Groundwater Monitoring Evaluation
~~Pine Bluff Arsenal~~ (PBA)
Pine Bluff, Arkansas
EPA I.D. NO. AR0213820707

December 16, 1985

SUMMARY

Figure 4. Impoundment monitoring wells and water table (based on December, 1984 readings)

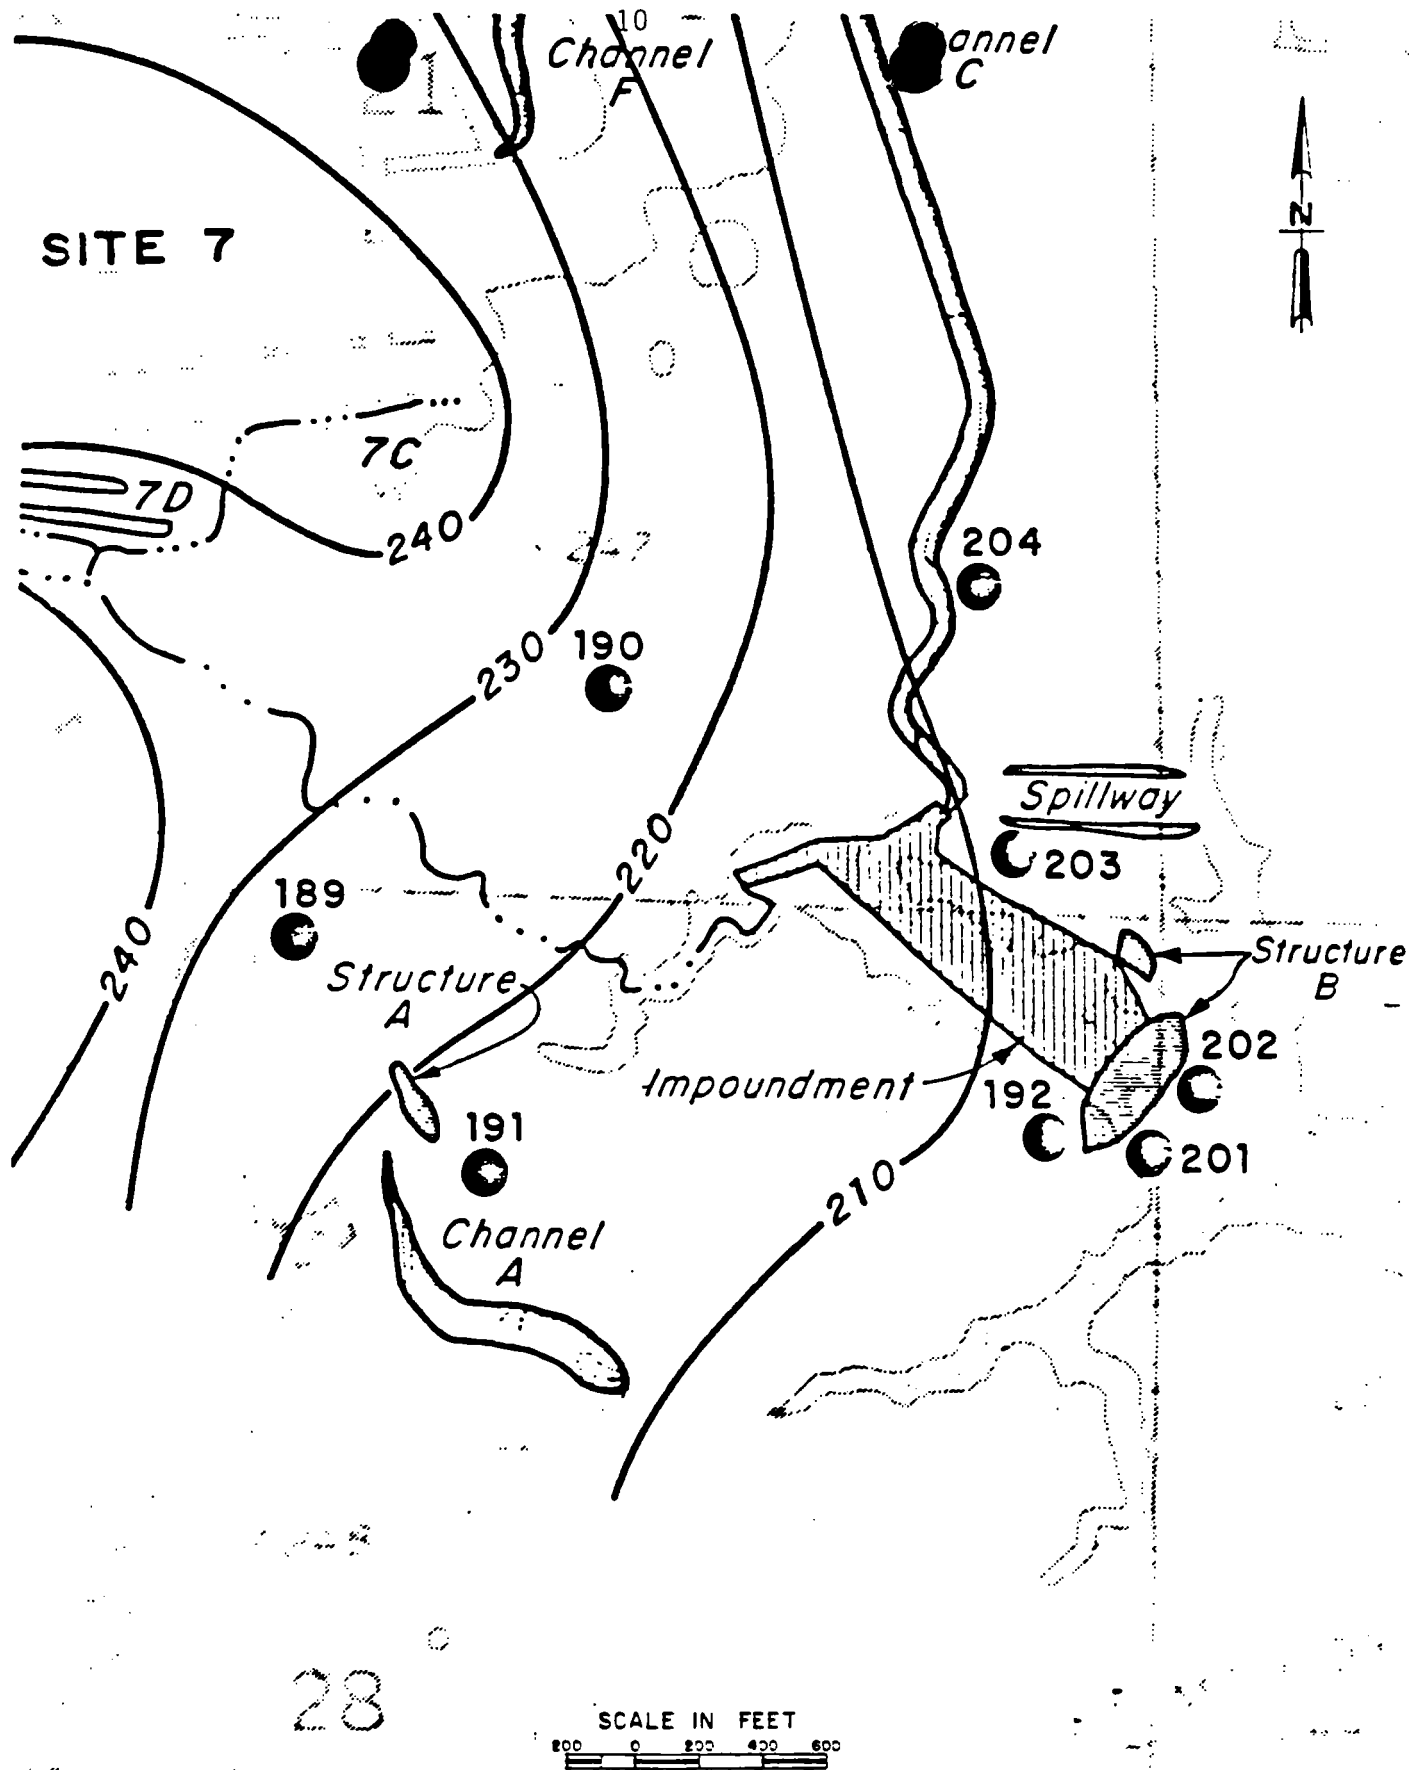
The total organic carbon (TOC) levels in Well 201 were relatively high compared to the other wells. The March 1985 values for Well 201 was 18.0 and the values of the other wells ranged from 2.5 - 4.9. The total organic halogen (TOX) levels in Well 203 were relatively high (1.570 mg/l - 1.750 mg/l) compared to the other wells (0.028, 0.093).

High levels of TOX in Well 203 were reportedly due to the presence of chloroform and chlorobenzene. Chlorobenzene measured 160 ug/l in Well 203 but was below detectable limits (5.0 ug/l) in all of the other wells. PBA reports that chlorobenzene is the result of the DDT operations.

According to the PBA report, very low levels of the pesticides DDT and DDD occur in downgradient wells 201 and 202 (DDT was 0.17 and 0.11 ug/l for these wells respectively and DDD was .10 and .33 ug/l respectively).

The surface run-off control impoundment site should be moved into the assessment phase of groundwater monitoring to determine the extent of the groundwater contamination which could be emanating from Site 7, 11, or another PBA site.

Figure 5. Landfill monitoring wells and water table (based on December, 1984 readings)

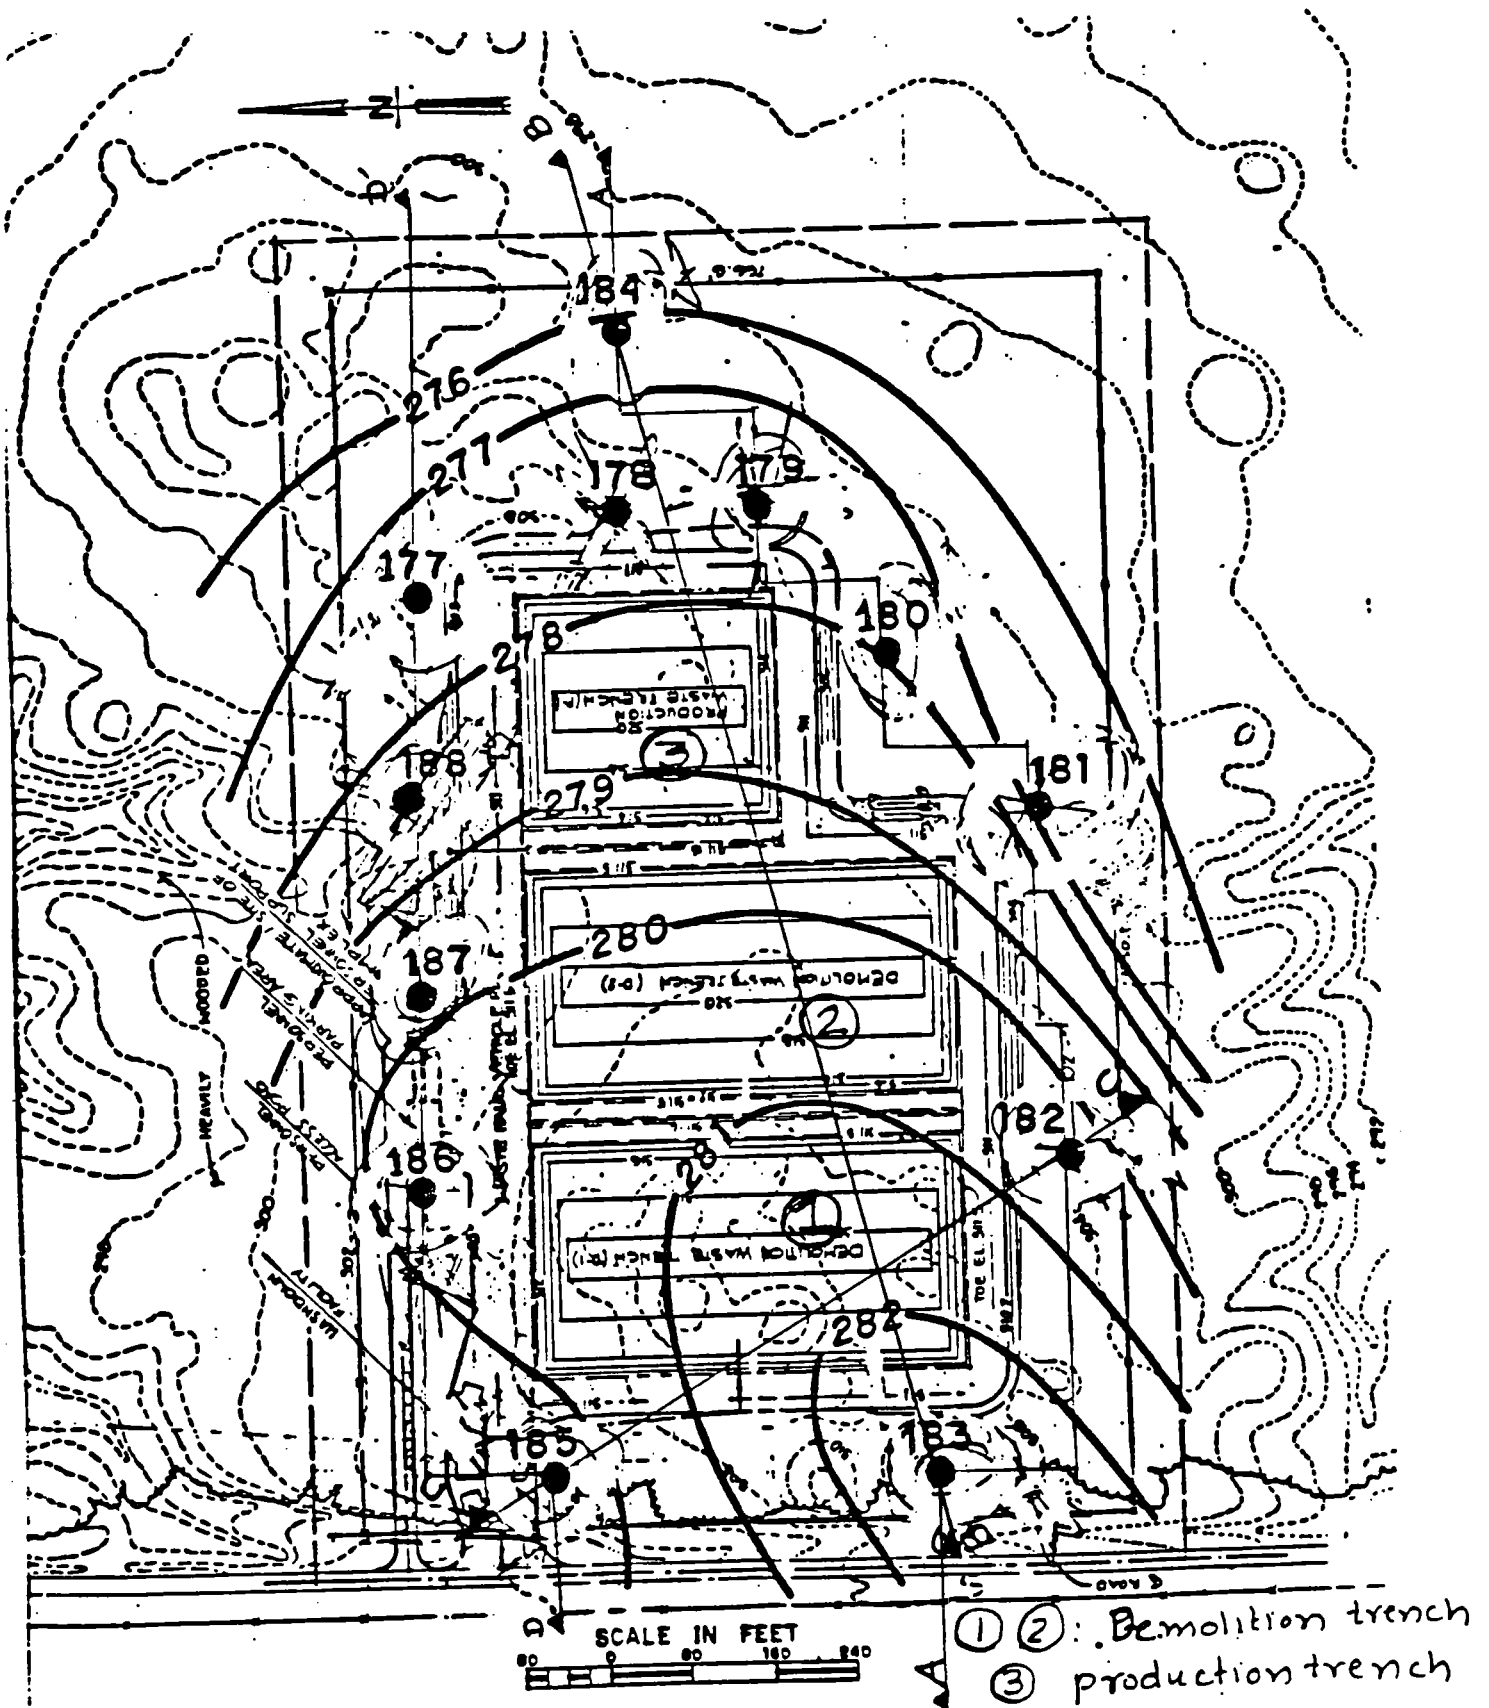
- ° The excessive length of most of the sand packs allows excessive dilution which reduces the sensitivity of the monitoring system for detecting contaminants.
- ° All wells are inadequate for the effective collection of volatile samples (chlorobenzene) as described in the permit. The turbulence from the high volume submersible pump results in loss of volatiles which can result in false values. Bailers are the preferred method for collecting volatile samples, however permanent caps on the monitor wells prevent the usage of bailers.
- ° WELL 184 (downgradient)

This well is inadequate because the excessive length of the sand packs (39 feet) causes excessive dilution which greatly decreases the ability of Well 184 to detect contaminants in the uppermost aquifer (Figure 8). Due to its location (downgradient of Well 178), Well 184 is not a necessary monitor well in this monitoring system (Figure 5).

Figure 9. : 1985 Landfill PBA, C-C' Geologic Cross-section with Water Levels, October, 1985.

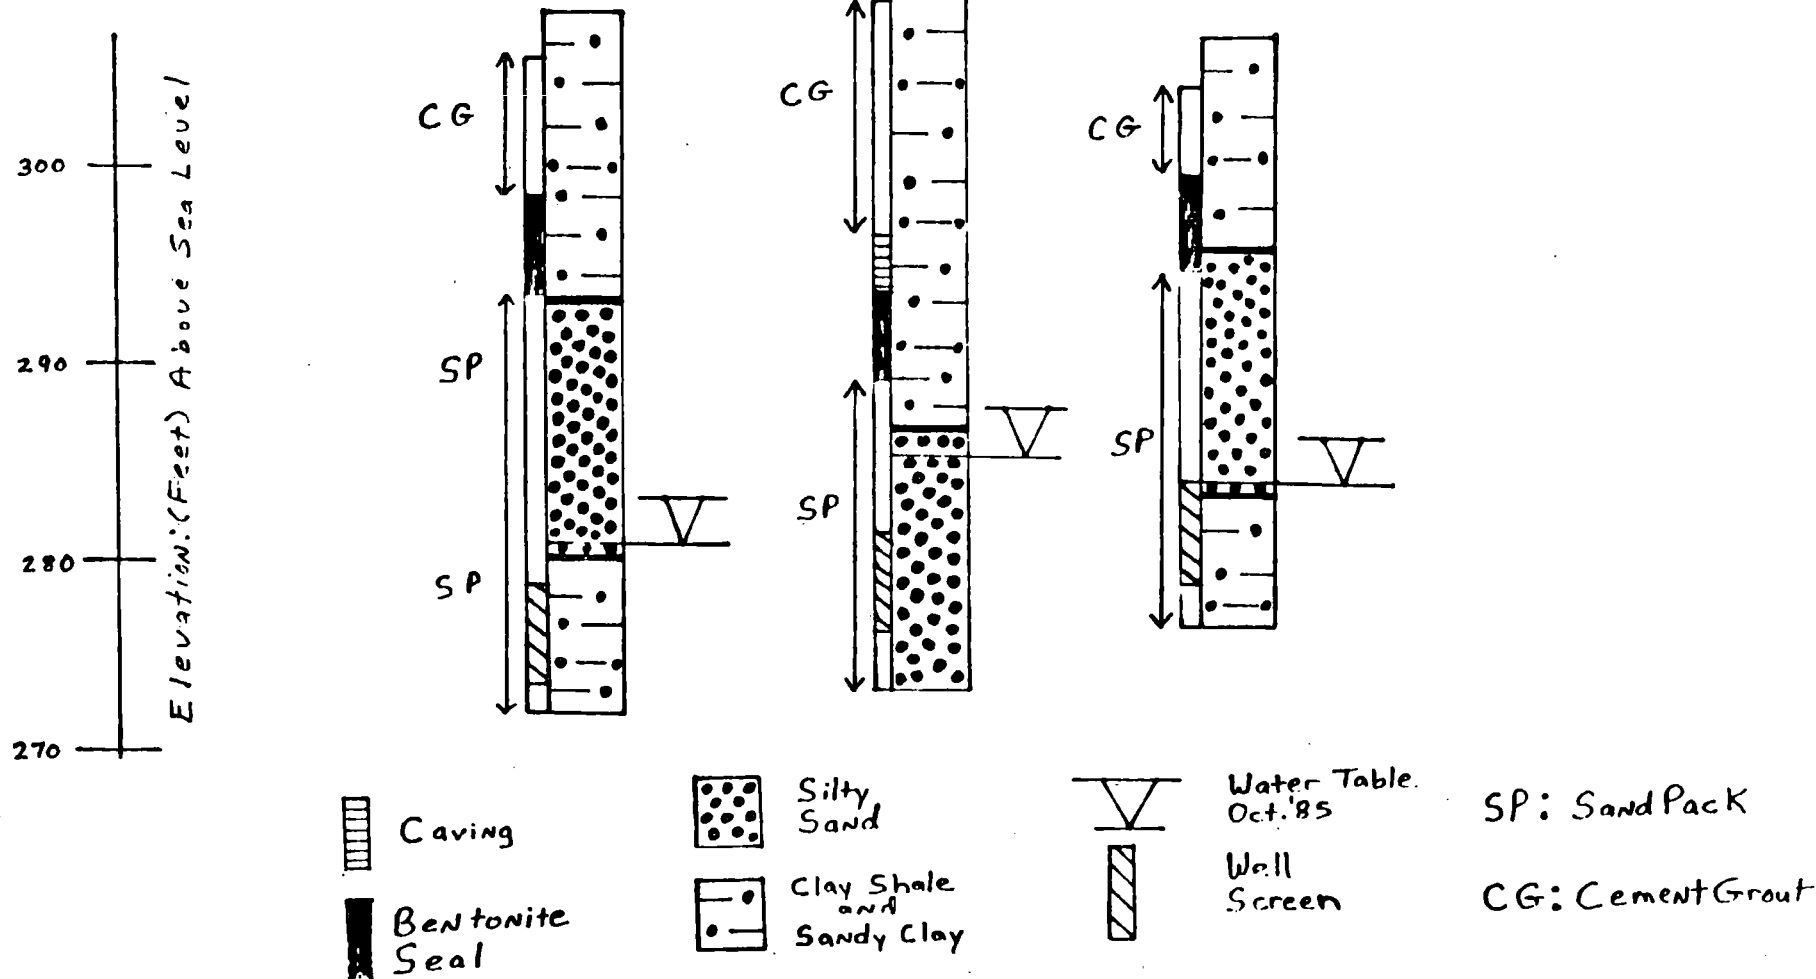
Another problem with the design of Well 181 is that the sand pack does not monitor a more permeable sandy zone which is a potential pathway for contaminant migration. This sandy zone intersects the water table zone and is illustrated in Figure 8. Contaminants could potentially move laterally along this unmonitored sandy pathway instead of downward and thus escape detection. Thus, this well is inadequate for the detection of contaminants passing the point of compliance.
